CITY OF STOUGHTON
DEPARTMENT OF
PLANNING & DEVELOPMENT
207 S. Forrest Street, Stoughton, WI. 53589

Subject: Agenda Item for the October 12, 2020 Plan Commission Meeting

Approving a Fence Renovation at 109-113 E. Main Street, Stoughton, WI.

I have completed a review of the proposed fencing at 109-113 E. Main Street. The downtown design overlay zoning district requirements are outlined below. This request is planned for review/approval at the October 12, 2020 Plan Commission meeting of which you will receive notice. You and/or your representative are required to attend the virtual meeting to answer questions.

901-JXR
580-ZBA

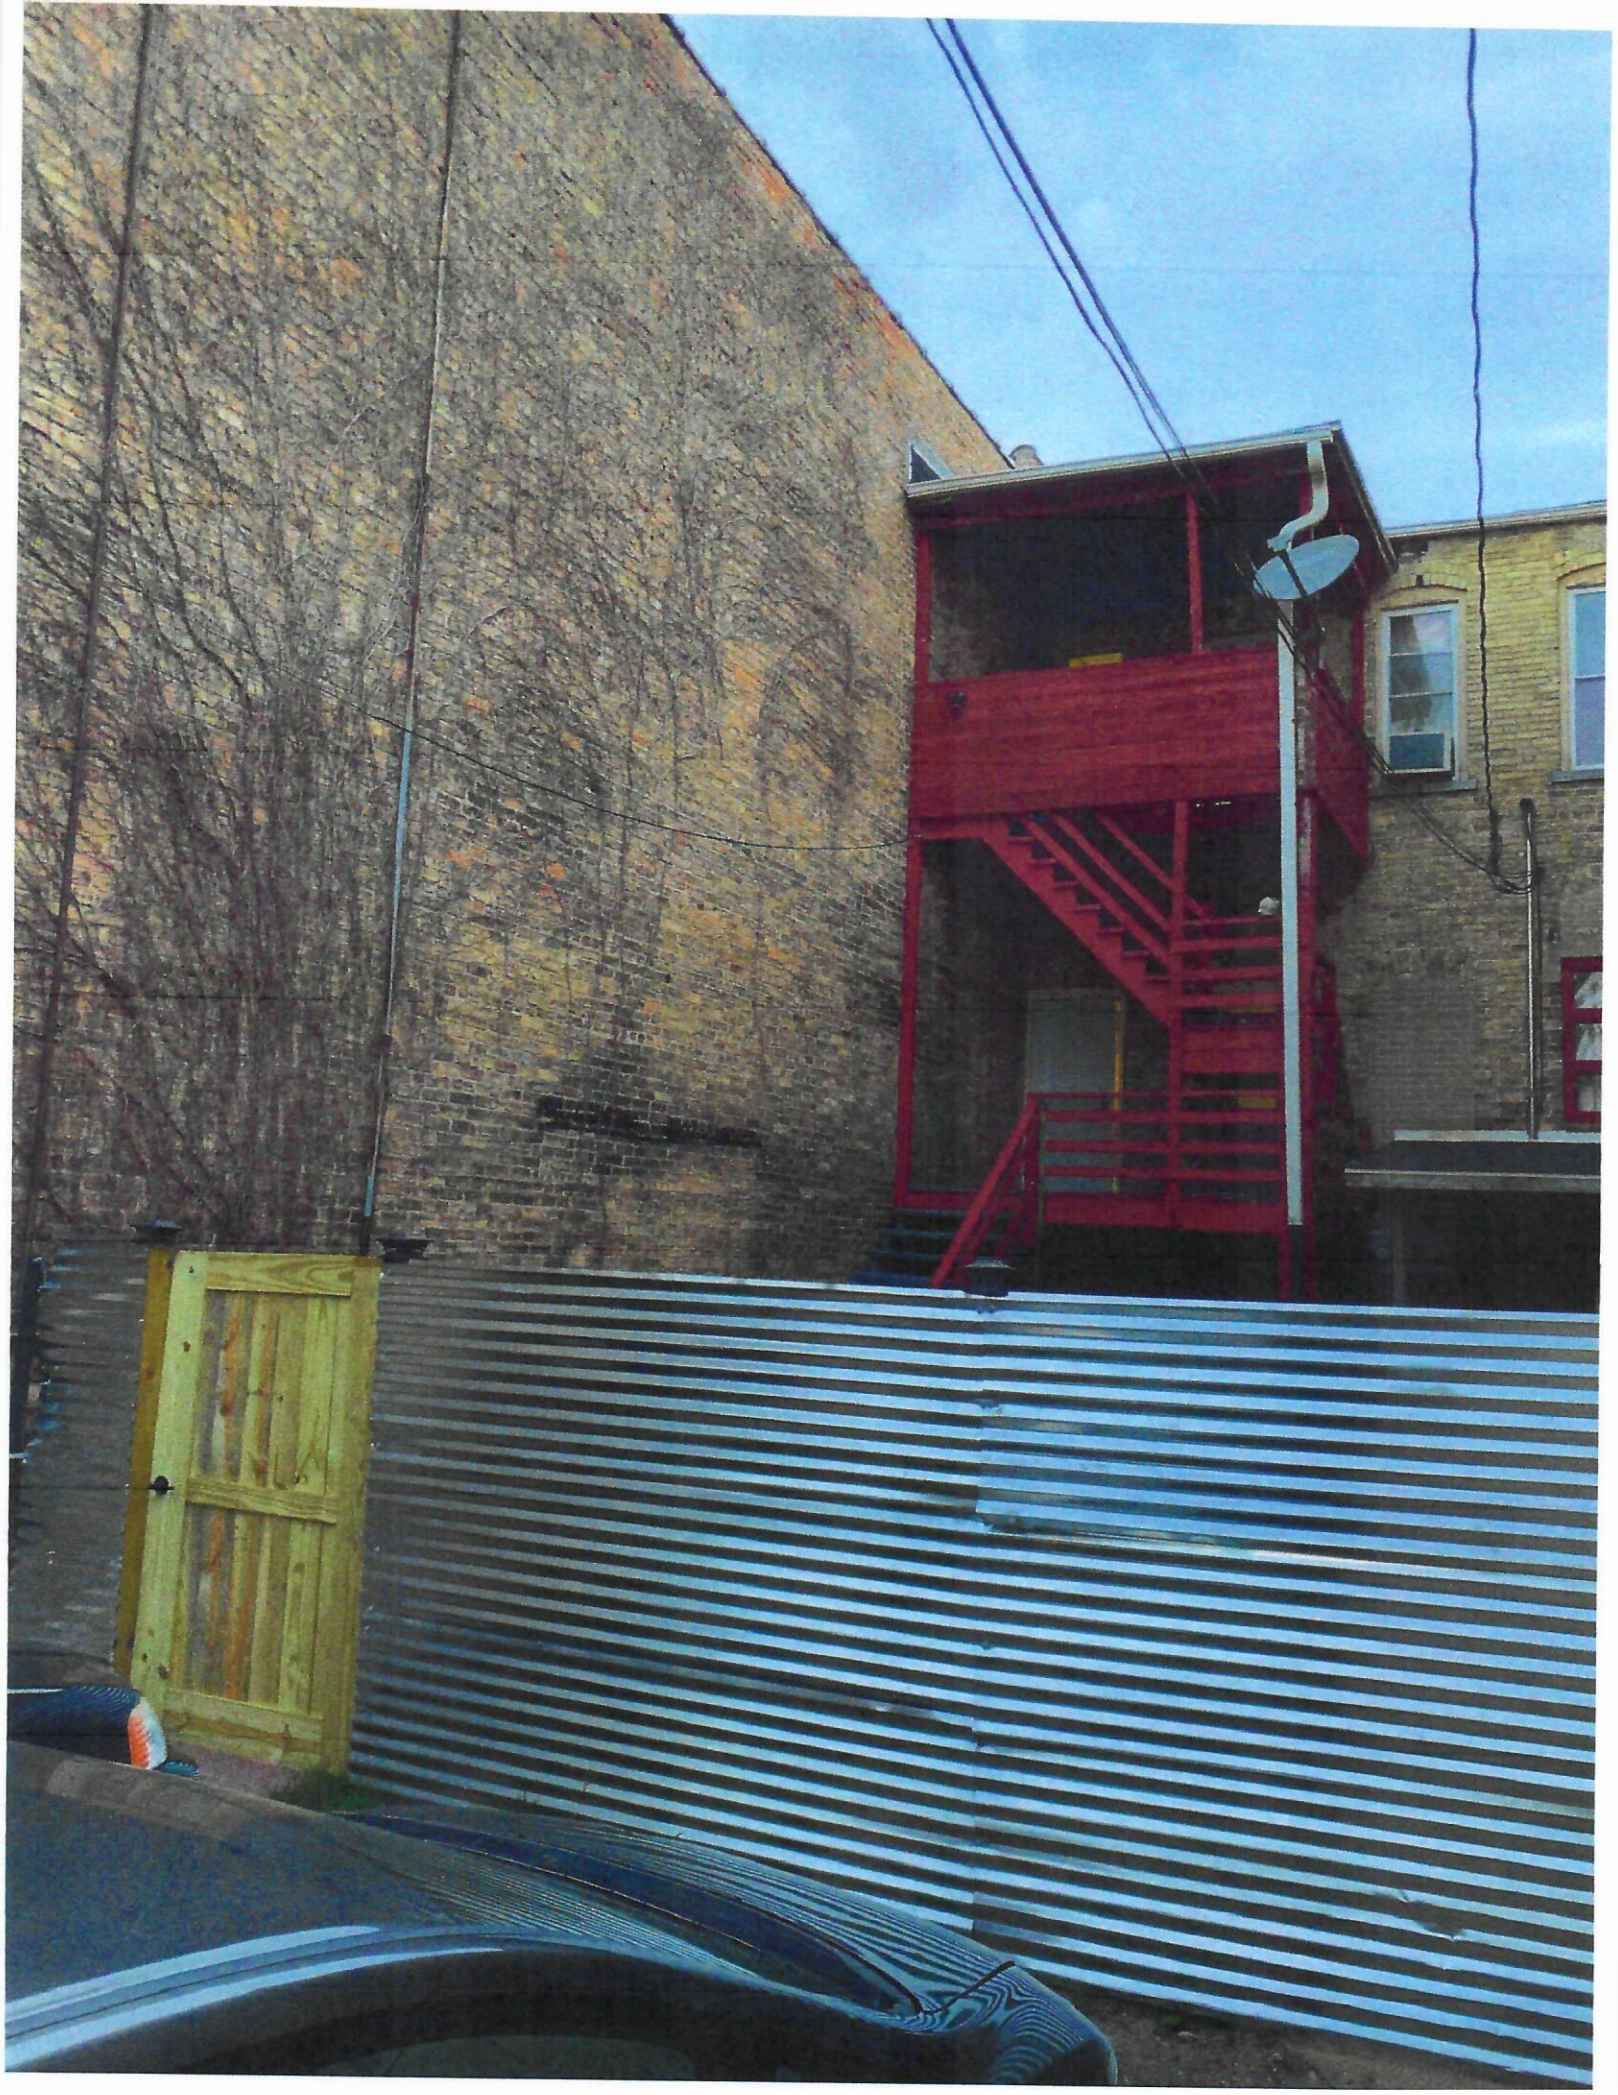
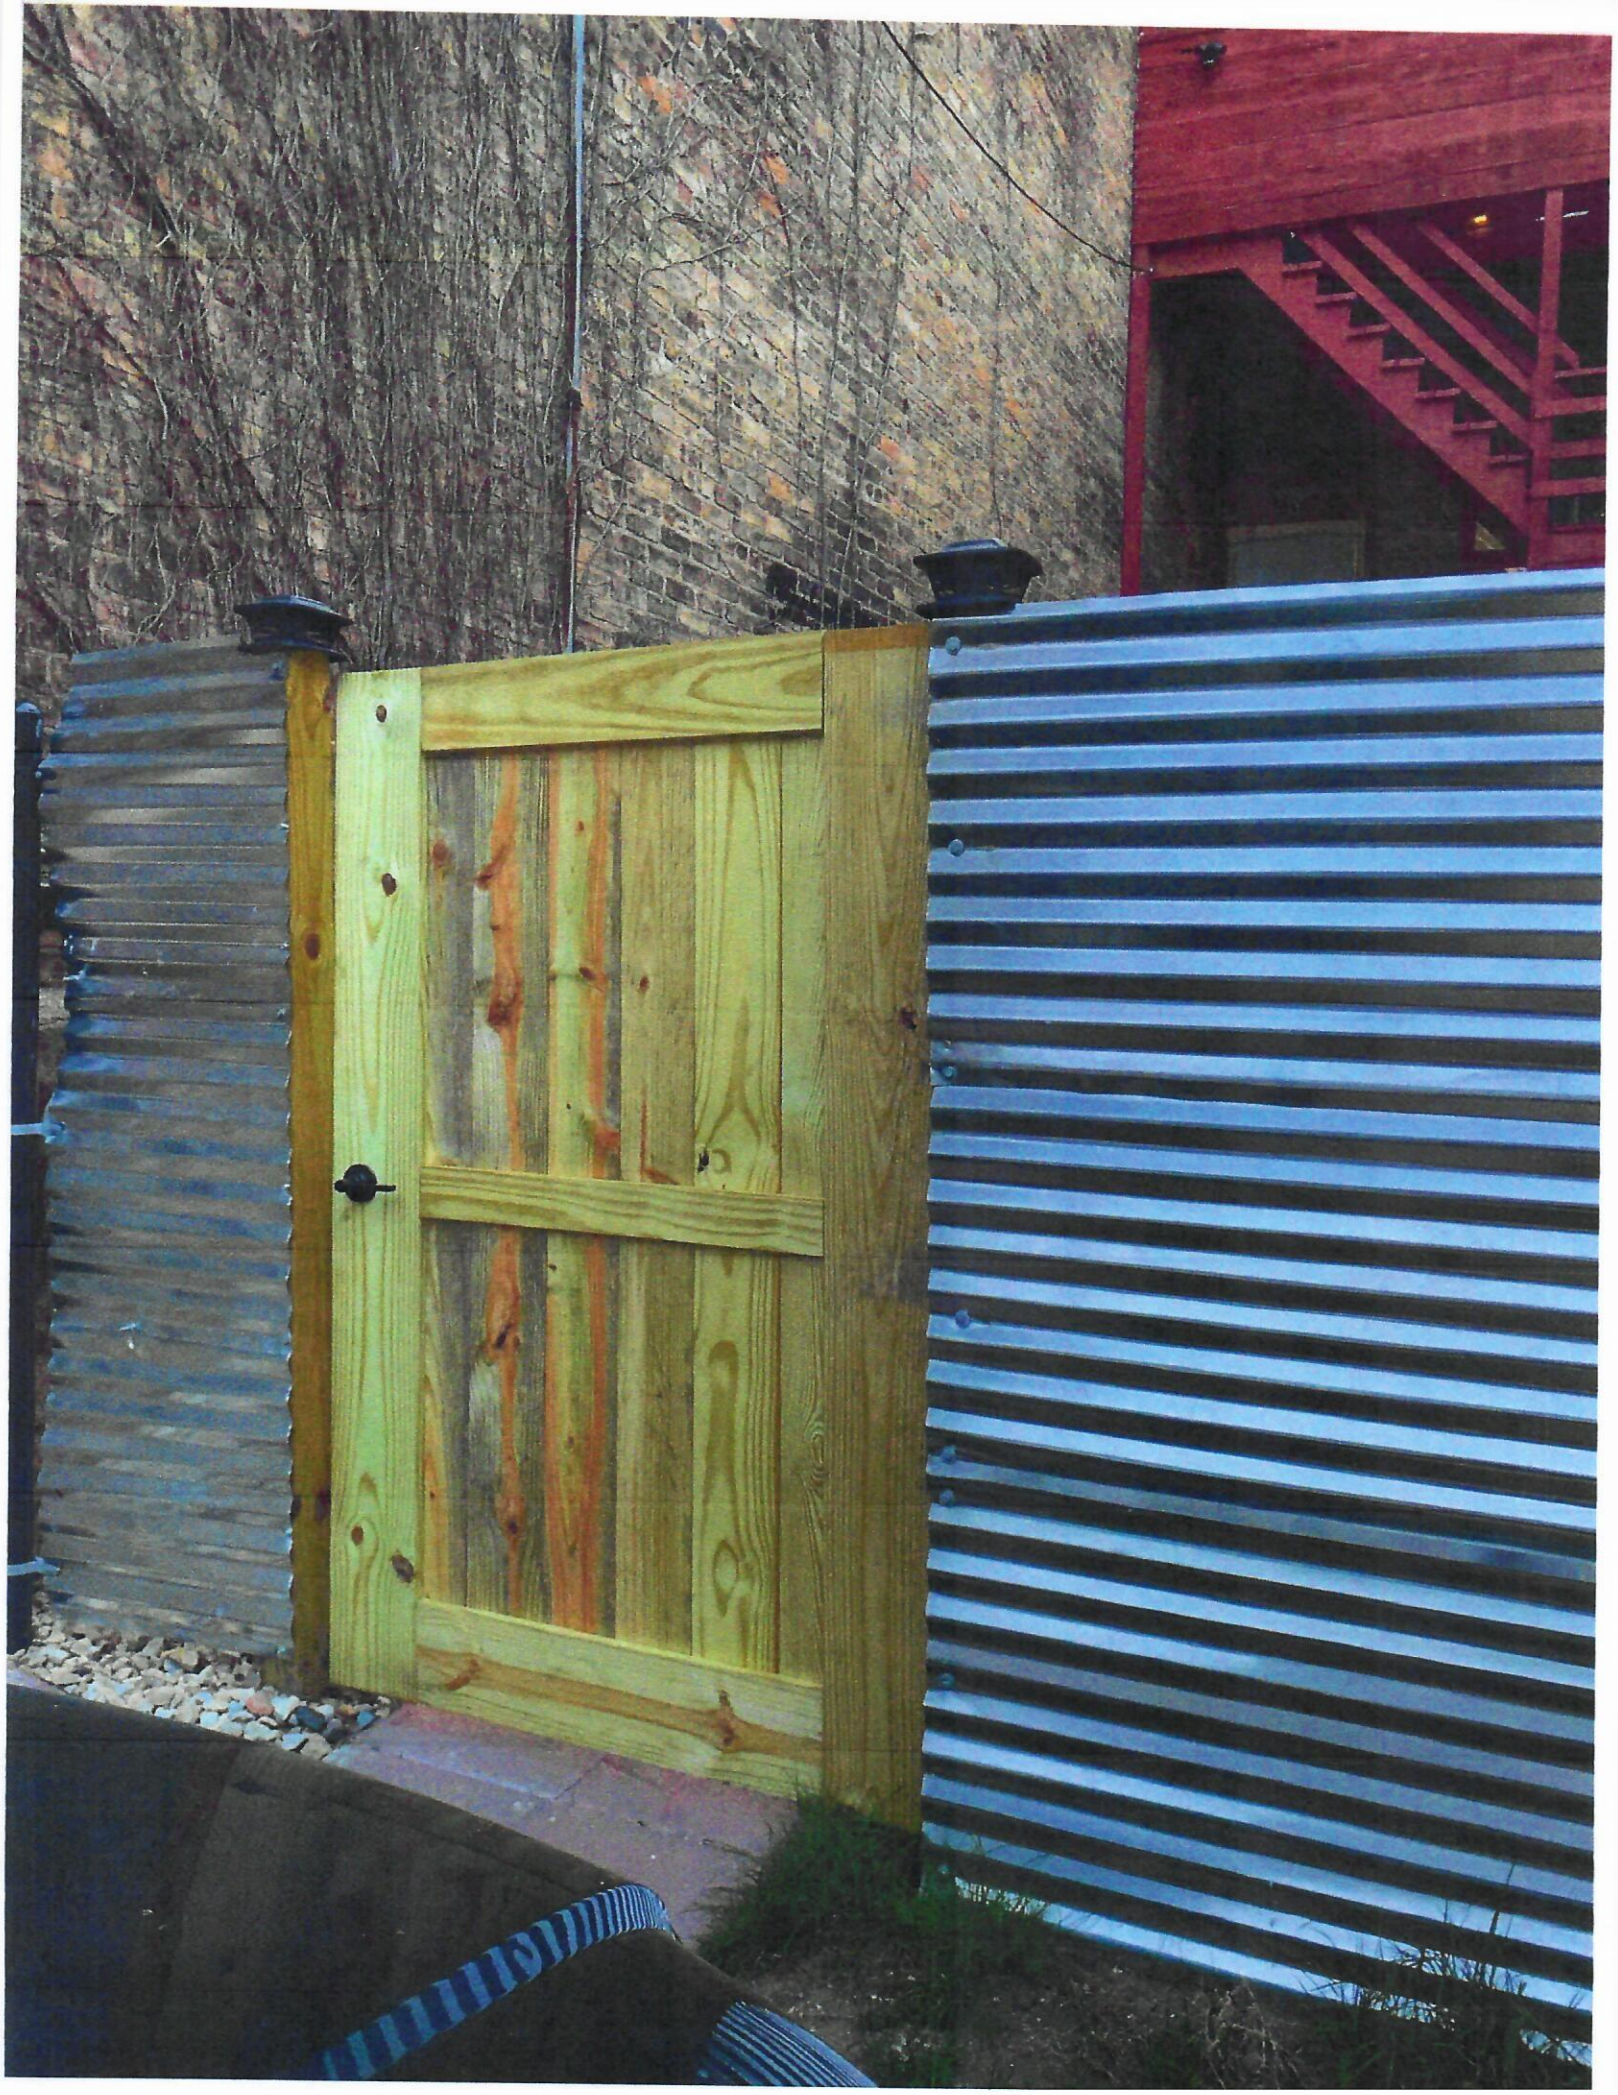
recommended and may be required by the city. **Before and after pictures are provided.**

3. A clear depiction of the proposed appearance of the property including paint charts, promotional brochures, and/or clear color photographs of replacement architectural components. Scaled or fully dimensioned drawings of proposed components such as windows, doors, railings, fencing or other site components, and/or detailed building elevations which are proposed for alteration or replacement are recommended and may be required by the city. **Pictures are provided.**
4. A clear written description of the proposed modification, including a complete listing of proposed components, materials, and colors. **Provided.**
5. A clear written explanation regarding how the proposed alteration will conform to section 78-517(7) with direct reference to each applicable design standard. **Explanation for the change is provided but not how it conforms to section78-517(7).**
